Access Compliance Report

Public Rights-of-Way

Intersection ID: 44008	Main Street: ARCOLA_LN	Cross Street: DEMAINE_DR	Location: W
ADA ID: AD12E5C79ECF	Ramp Type: BlendTrans1	Initial Pass/Fail: Pass	Overall Compliance: No
Severity Score: 22.75			
Codes/Mitigation Info/Possible Solution		Field Measurements/Component Compliance

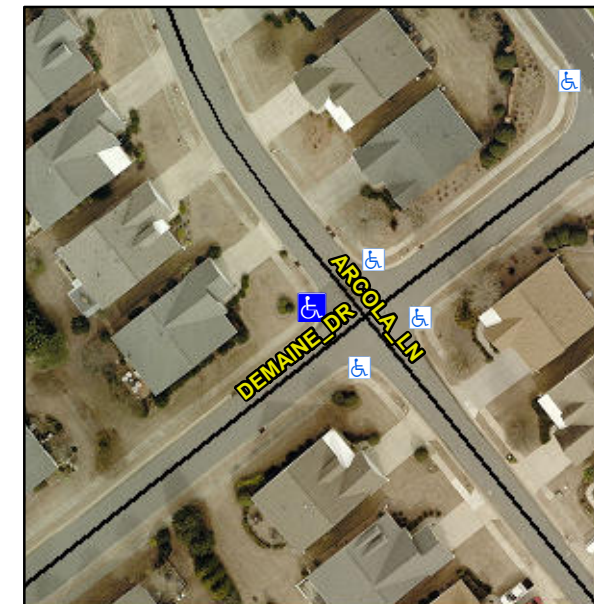
Not Found, R304.5.3, R304.2.1, R305, R302.7.2, R304.5.4

Compliance	Description	Data	Compliance	Description	Data
N/A	Ramp Length (in)	46.0	Yes	BlendTrans Slope (%)	3.9
Yes	Ramp Width (in)	52.0	No	BlendTrans XSlope (%)	2.7
N/A	Flare Type LT	Sloped	N/A	Flare Type RT	Sloped
N/A	Flare Slope LT (%)	2.9	N/A	Flare Slope RT (%)	5.0
N/A	Flare Traversable LT?	No	N/A	Flare Traversable RT?	No
No	Landing Length (in)	47.0	No	DWS Provided?	No
Yes	Landing Width (in)	52.0	N/A	DWS Contrast?	No
Yes	Landing Slope (%)	1.7	N/A	DWS Length (in)	N/A
Yes	Landing X Slope (%)	0.6	N/A	DWS Full Width?	No
N/A	Landing Curb? (Y/N)	No	N/A	DWS Offset (in)	N/A
N/A	Shared Landing?	No			
Yes	Gutter Ponding?	No	No	Gutter Slope (%)	7.8
No	Gutter Lip Ht (in)	0.3	Yes	Gutter X Slope (%)	0.9
N/A	Painted X Walk1?	No	N/A	Painted X Walk2?	No
	X Walk 1 Direction	To SE		X Walk 2 Direction	To NE
	X Walk 1 Width (in)	N/A		X Walk 2 Width (in)	N/A
	X Walk 1 Slope (%)	1.8		X Walk 2 Slope (%)	1.3
	X Walk 1 X Slope (%)	1.3		X Walk 2 X Slope (%)	1.0

N/A	Ramp inside XWalk1?	N/A	N/A	Ramp inside XWalk2?	N/A
	Road Slope (%)	0.1		Clear Space?	Yes
	Road X Slope (%)	2.7	N/A	Clear Space to XWalk (in)	N/A
Yes	Any Obstructions?	No	Yes	Storm Grate/Utility Hazard?	No
	Obstruction Type			Storm Grate/Utility Type	
		N/A			N/A
			Yes	Surface Condition? (G/P)	Good
			No	Curb Slope (%)	5.2

Remove & Replace Curb Ramp With Two New Directional Ramps or Equivalent. Remove & Replace Gutter.
